SERVICE BULLETIN

Service Bulletin No.: DA20-32-06 Rev 0

Title: NLG Wheel and Fork Installation
Improvements

Figure 1 - NLG Fork Assembly Installation

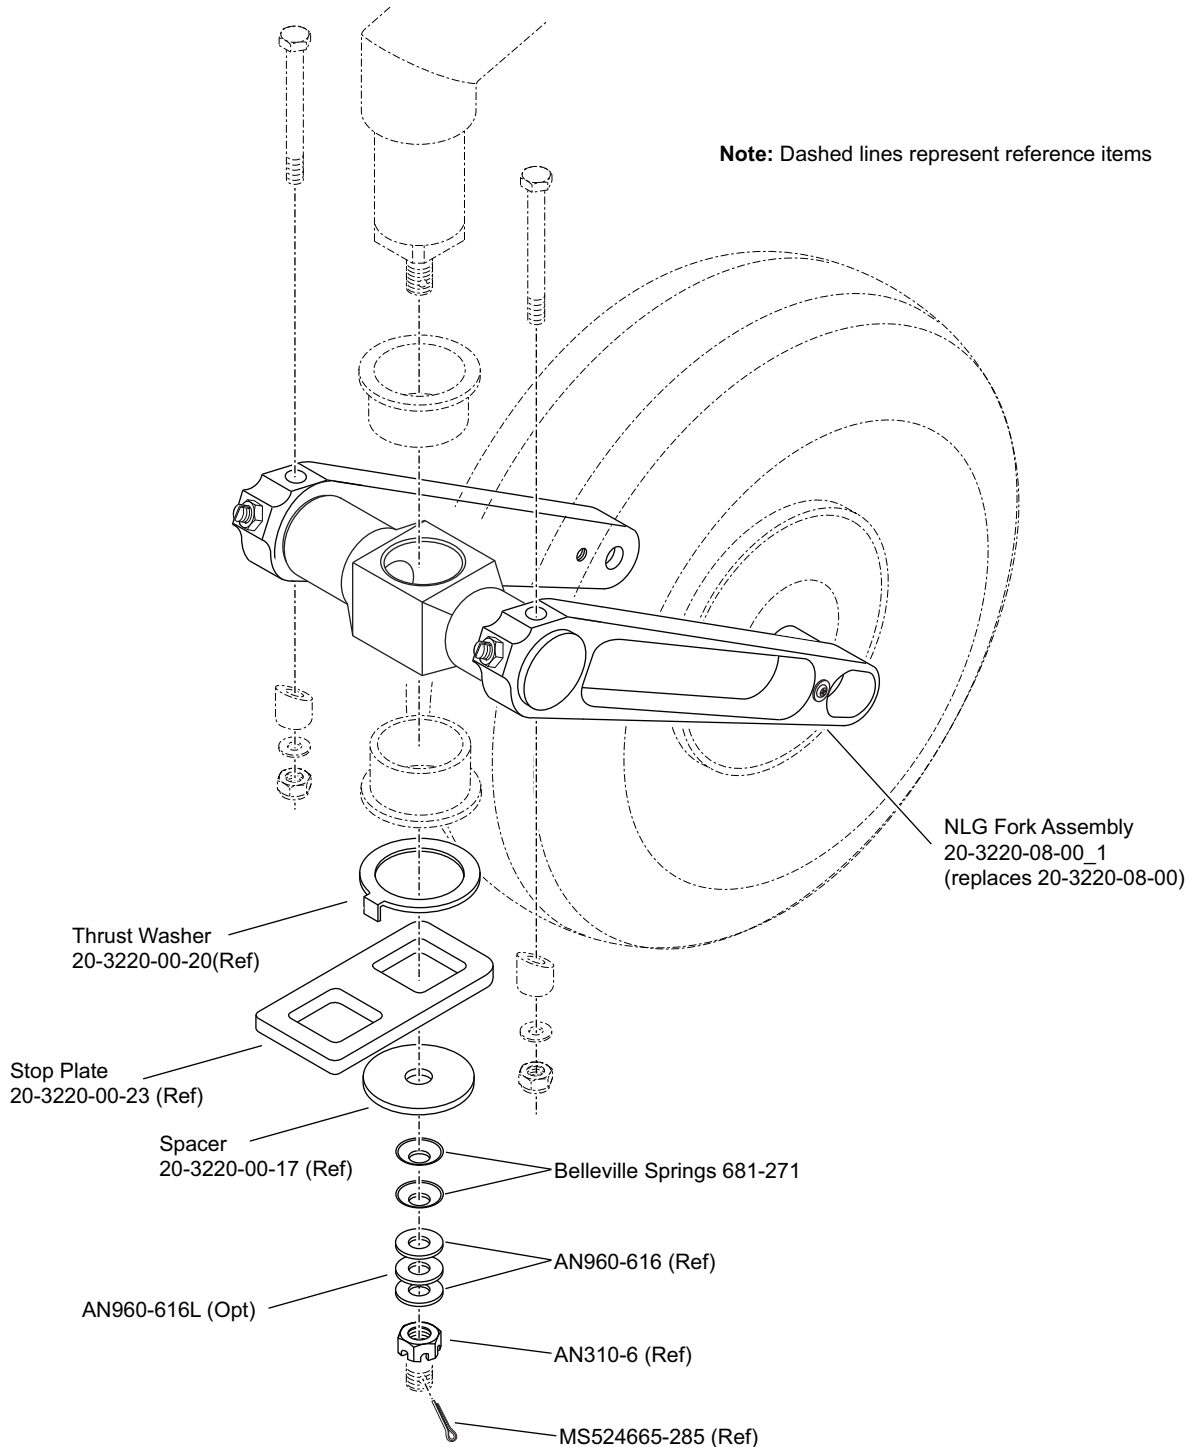
- 10.1 Either jack the aircraft in accordance with DA20-A1 AMM Chapter 07-10-00.
- 10.2 Remove the wheel in accordance with AMM Chapter 32-40-00
- 10.3 Remove NLG fork (A new fork assembly is available see SIL20A1-008) .
- 10.4 Inspect all parts for condition checking for cracks, corrosion and wear. New hardware should be used where necessary (For the fork assembly please review SIL20A1-008).
- 10.5 Apply CRC Corrosion Shell to the stud. Do not contaminate the tire or fiberglass.
- 10.6 Lubricate the axle in accordance with AMM Chapter 12-20-00.
- 10.7 Re install the fork using the new Belleville springs with the rest of the parts listed in figure 1. Be sure that both springs are installed with the open side facing up as per figure 1.

Figure 2 - NLG Wheel Installation with Shims

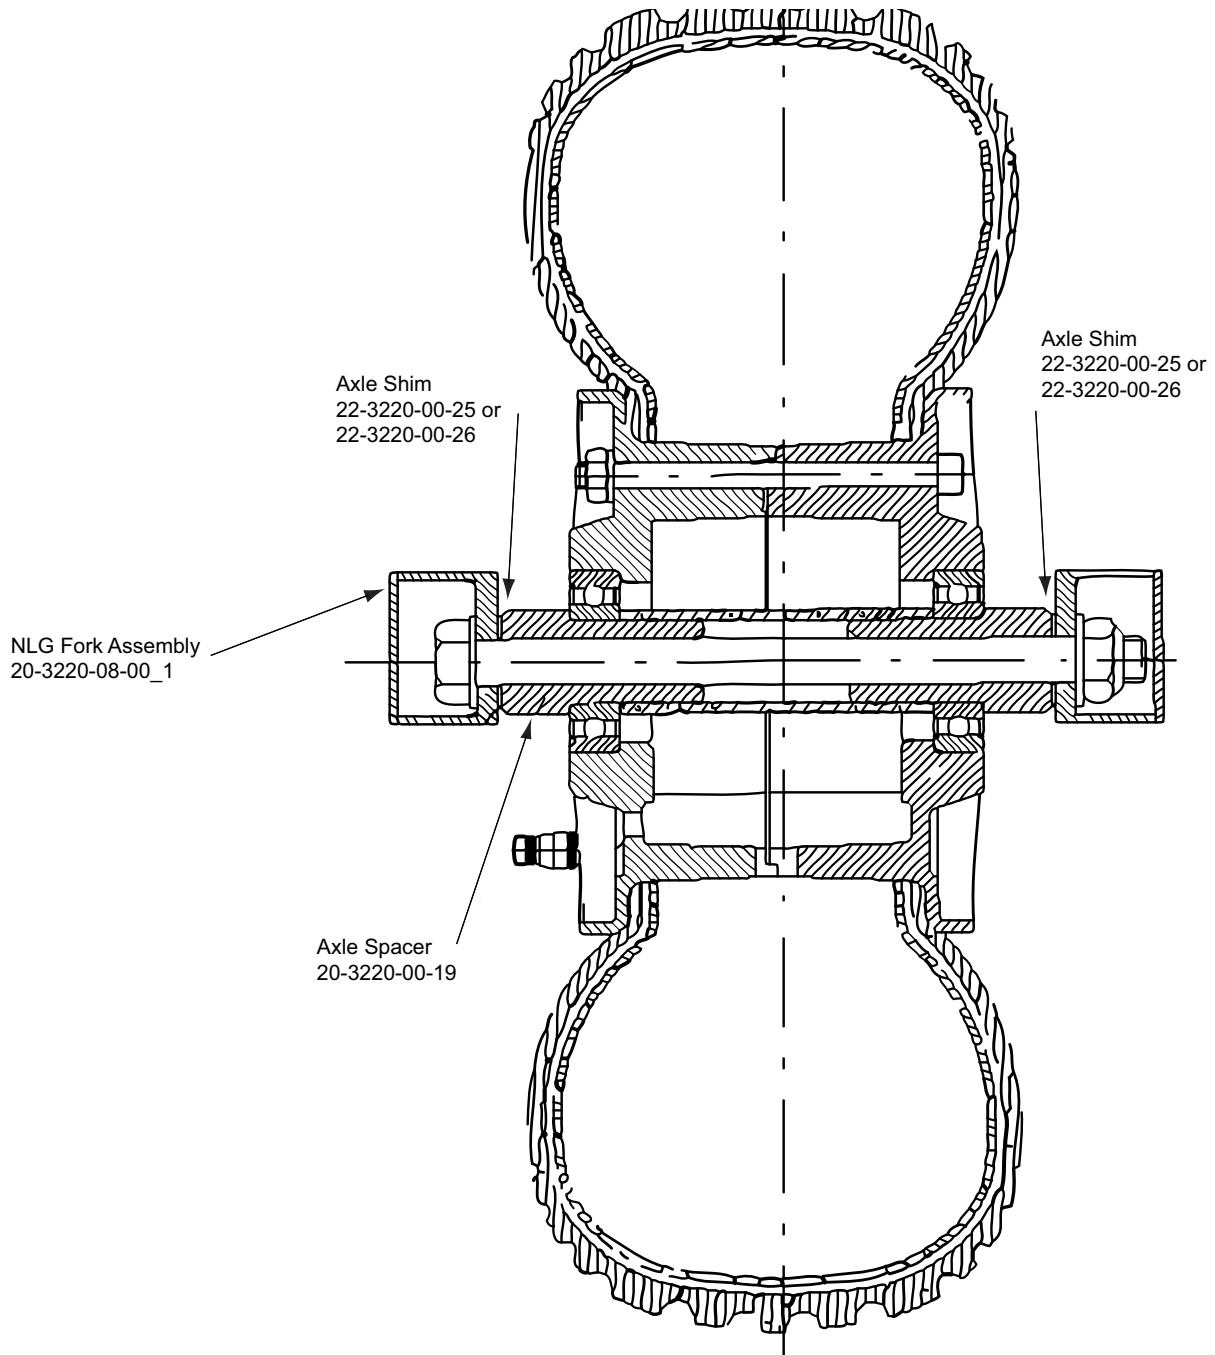
Note: The AN960-616L steel washer should be used if it is not possible to install the cotter pin correctly when adjusting the friction force.
- 10.8 Re install the wheel and use the shims to eliminate the gap between the axle spacer (20-3220-00-19) and the fork. Use a maximum of two shims and divide the shim installation evenly from side to side. Maximum difference between sides is 0.010". See figure 2.
- 10.9 Carry out friction adjustment as per AMM Chapter 32-20-00. Use the AN960-616L washer as noted above if required to properly install the fork and obtain the proper friction.
- 10.10 Make a log book entry that this Service Bulletin has been incorporated.
